Rezoning Transportation Analysis

Petition Number: 2025-070

General Location Identifier: 03736123

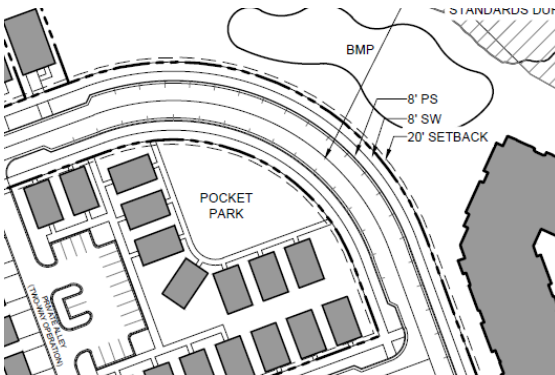
4. ~~**Outstanding Comment from 8/28/25:** Revise site plan and conditional note(s) to commit to show the extension and connection between proposed roads and existing roads. Site plan shall callout the proposed roadway stubs stating that the proposed stub shall connect with the adjacent existing roads. Add a conditional note also committing to this improvement.~~

Clarifying comment: Proposed roads need to connect to existing roads per UDO. Can not just stub, leaving a gap in pavement.

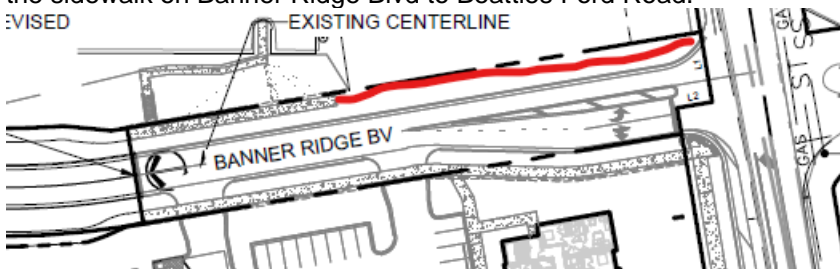
8. ~~**Outstanding Comment from 8/28/25:** Revise site plan and conditional note(s) to commit to extending the sidewalk on Banner Ridge Blvd to Beatties Ford Road.~~

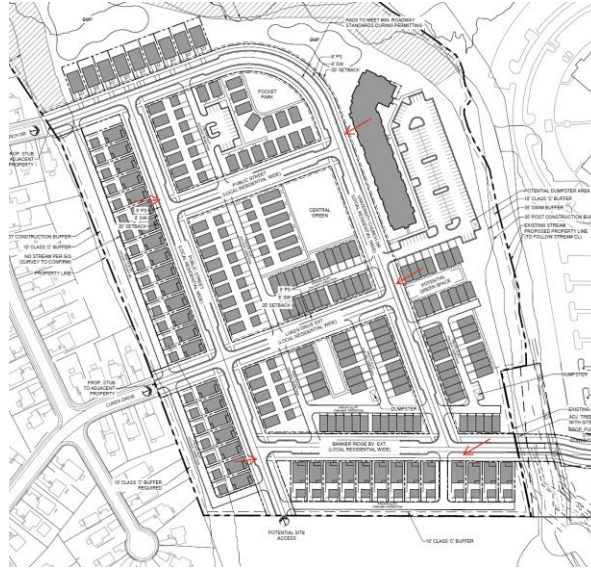
9. ~~Outstanding Comment from 8/28/25:~~ Revise site plan and conditional note(s) by adding pedestrian ramps to the intersections within the proposed development. You may need to adjust some of the on street parking stalls to accommodate.
